J&T Consulting, Inc.

April 8, 2024

RE: Bernhardt Sand and Gravel Pit, File No. M-2023-025,
112c Permit Application, Preliminary Adequacy Review

Reclamation Plan Map

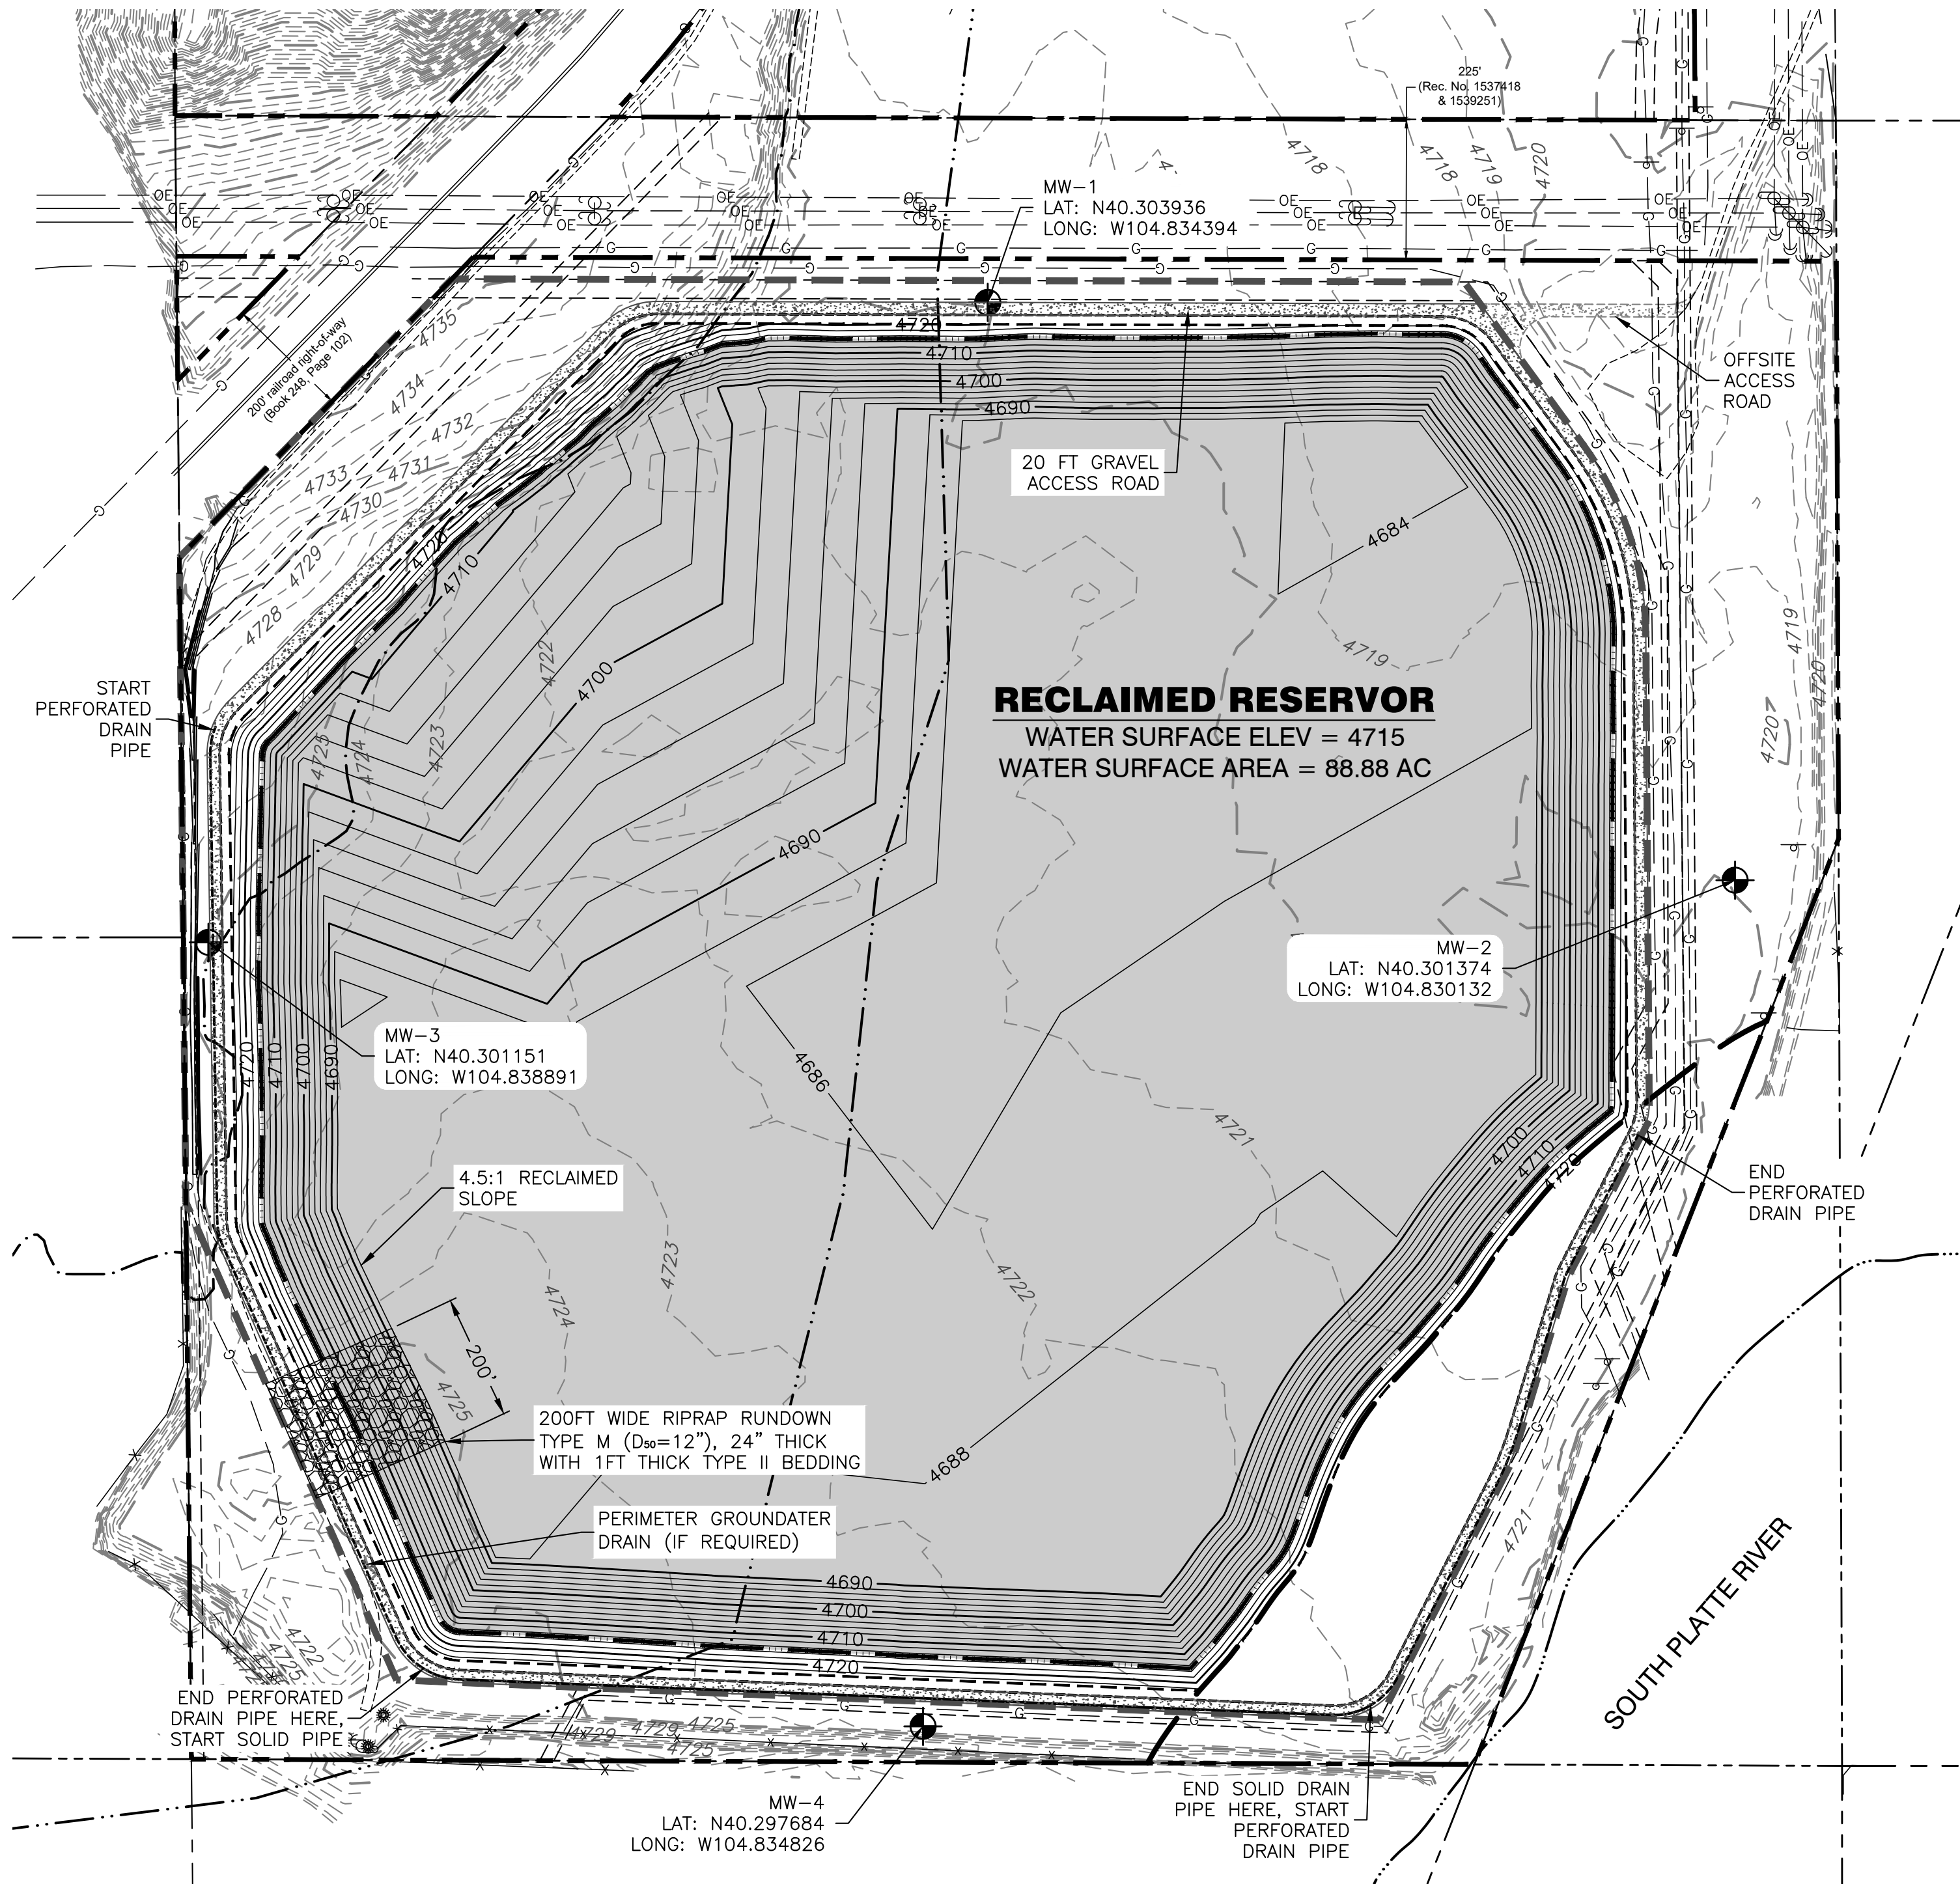
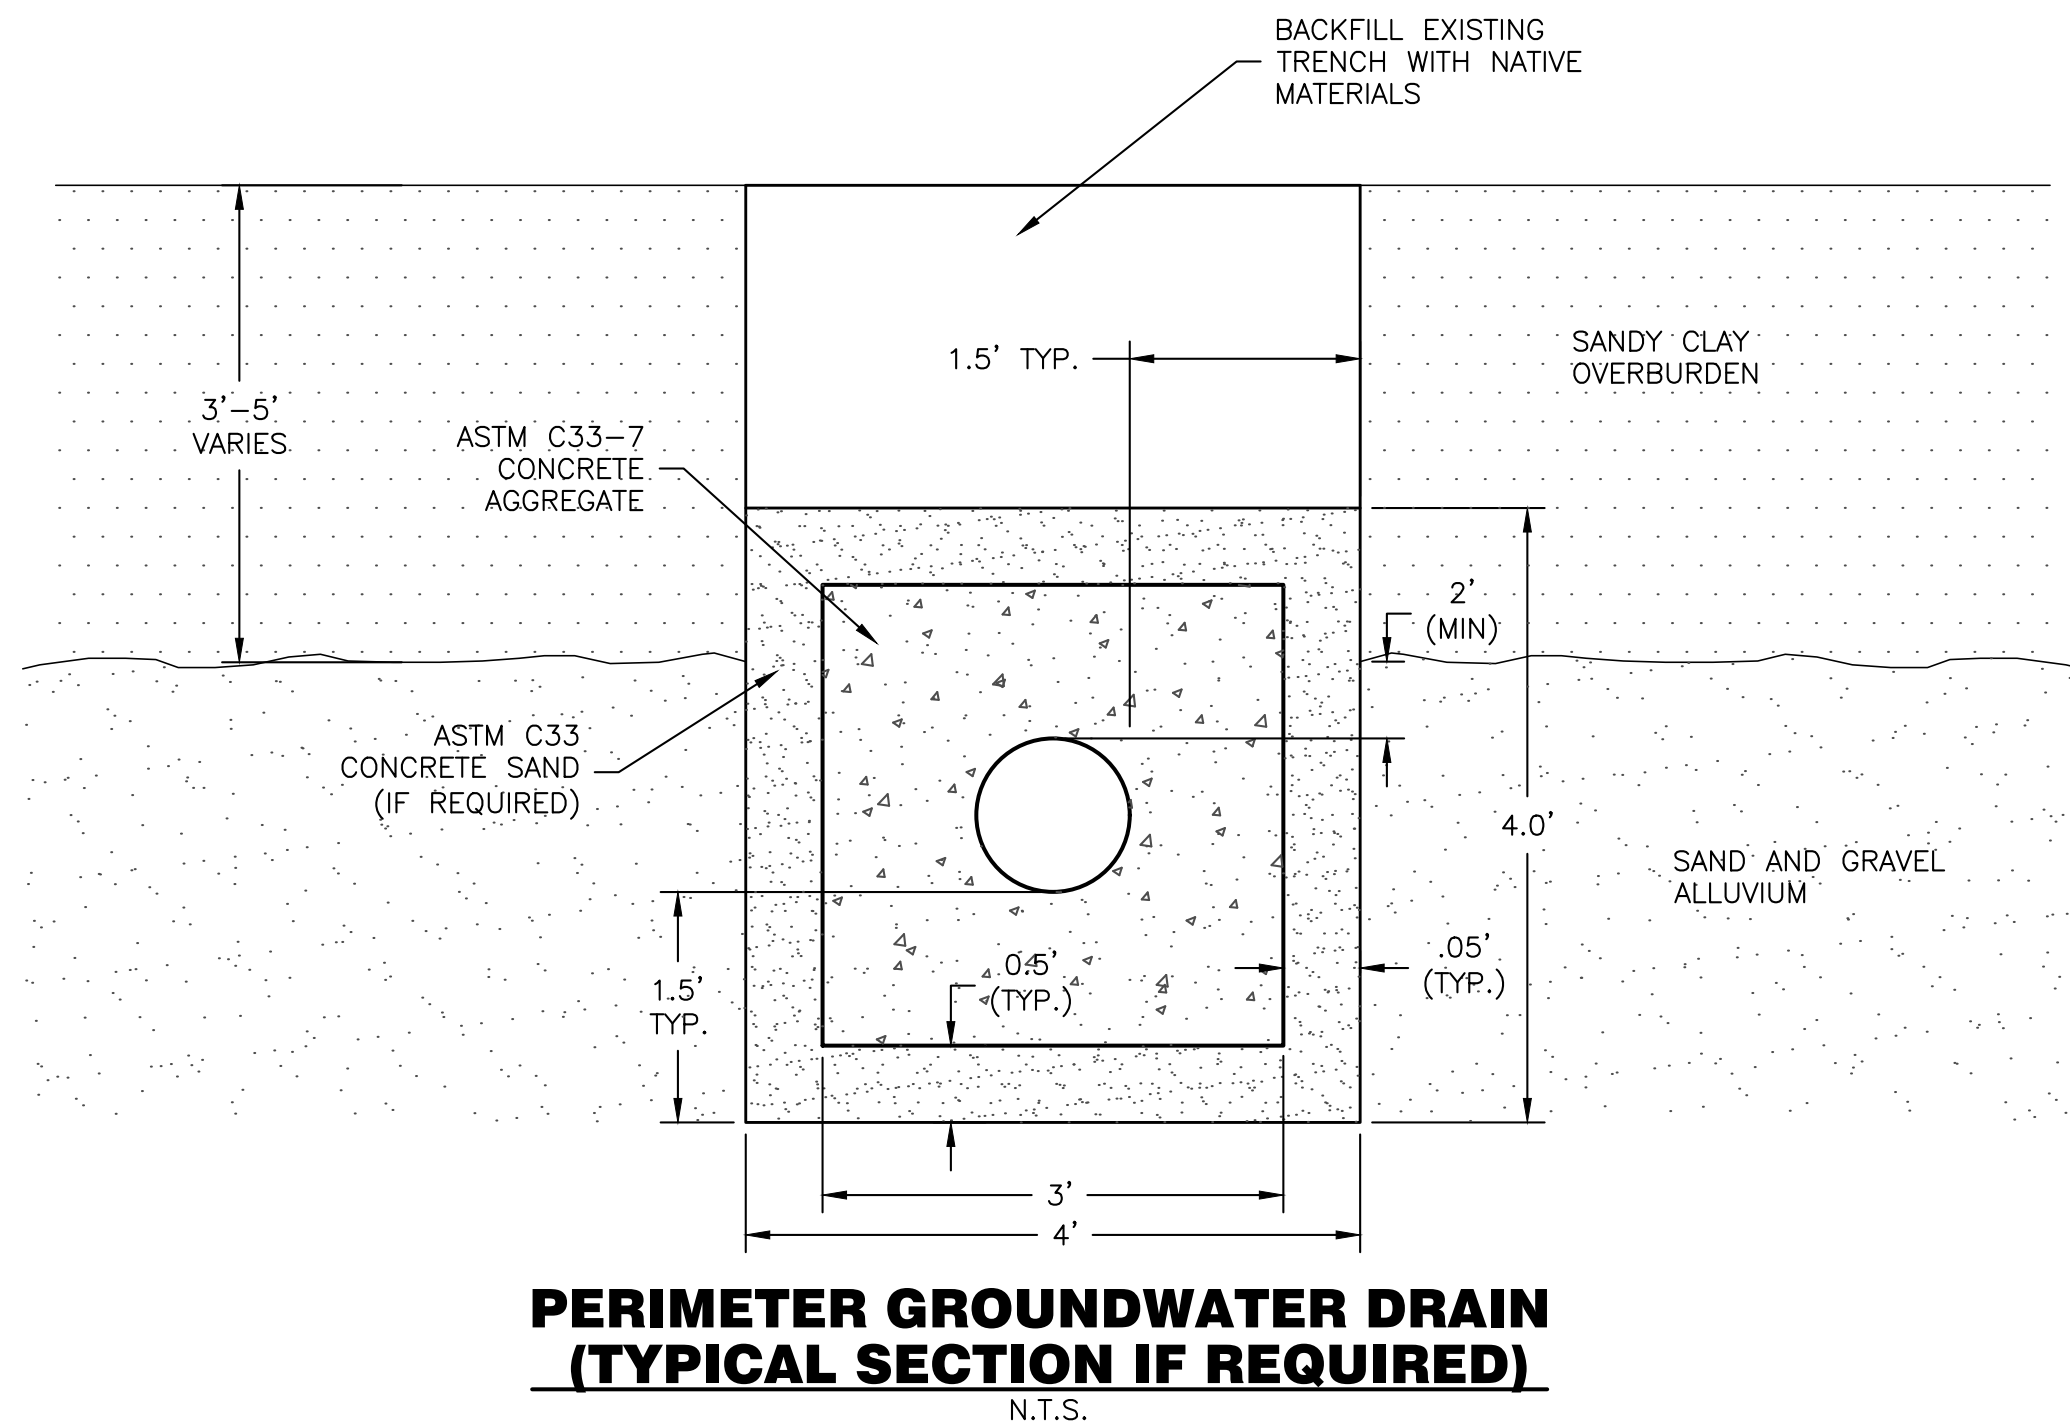
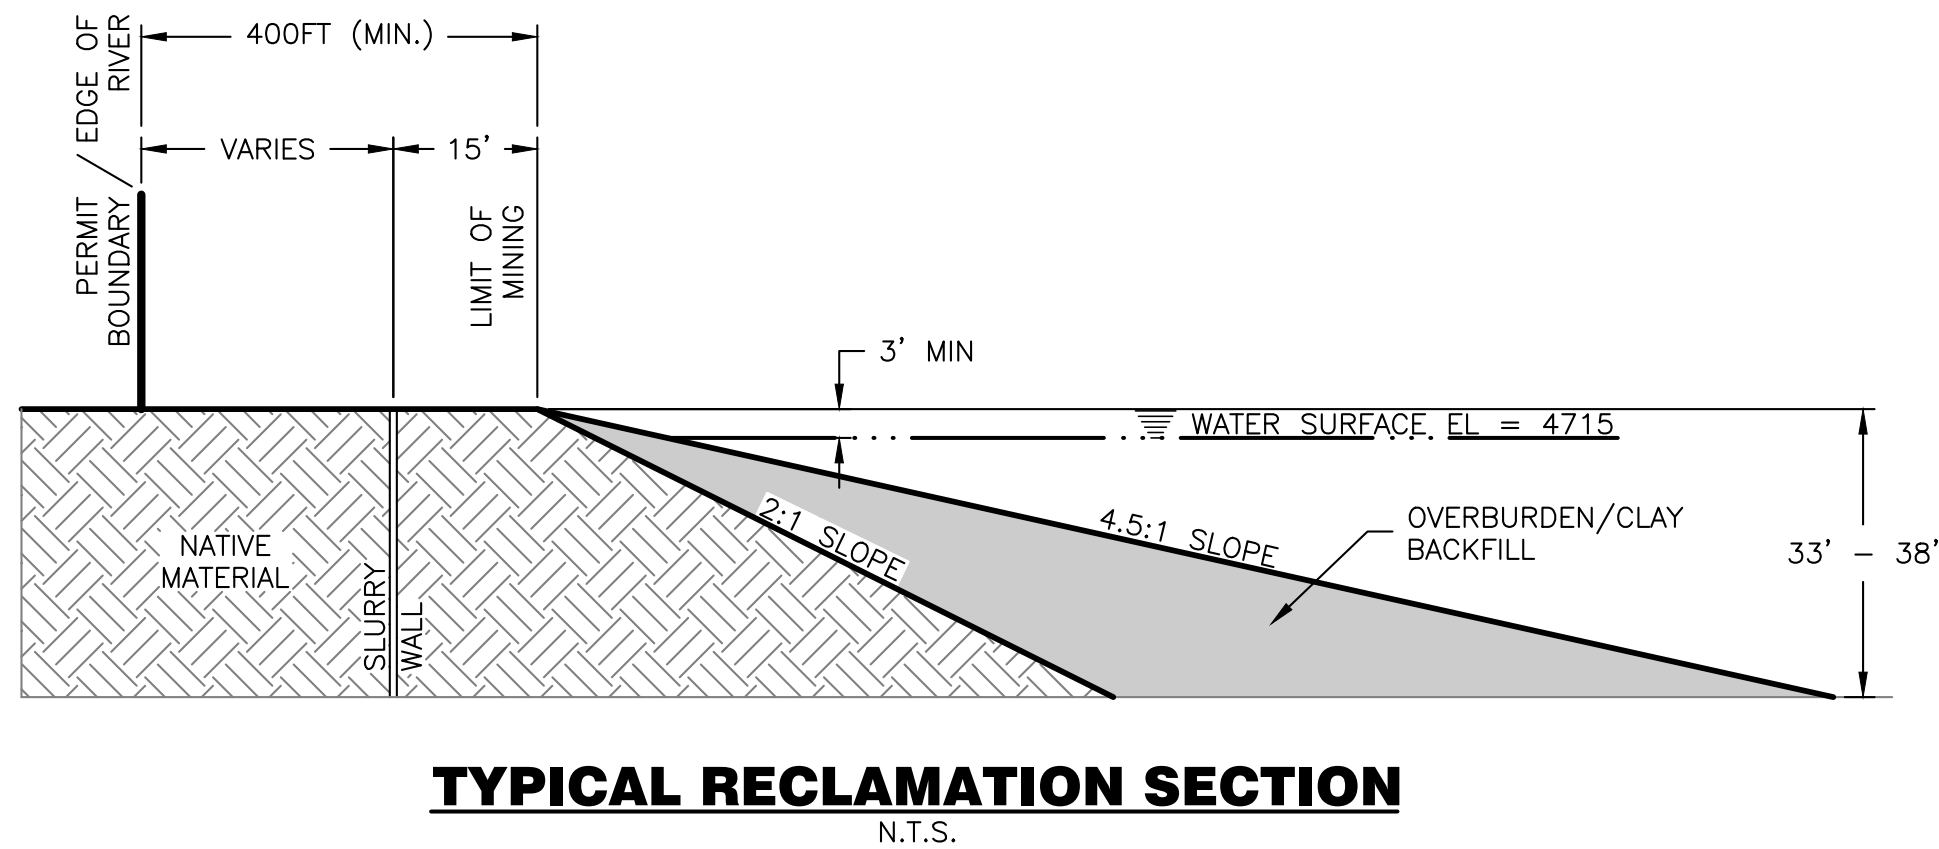
1. Revise the extraction and reclamation plans to include a 400-foot setback from the top of the riverbanks to the top of the pit side slope of the planned pit. This size of setback is based on guidance from the Mile High Flood District (MHFD). The document, "Technical Review Guidelines for Gravel Mining and Water Storage Activities Within or Adjacent to 100-year Floodplains," is available upon request. A smaller setback will be considered by the Division if rationale from this guideline (or similar reference) is given.

4) The Pre-Mining, Mining, and Reclamation Plan maps need to be updated to show the monitoring well locations associated with the proposed permit.

Response: The mining and reclamation plans have been updated to provide a 400-foot setback from the top of the river bank to the pit side slope/mining limit. (See the attached updated maps for the mining plan and reclamation plan).

Response: The Pre-Mining, Mining, and Reclamation Plan maps have been updated to show the monitoring well locations. (See attached updated maps)
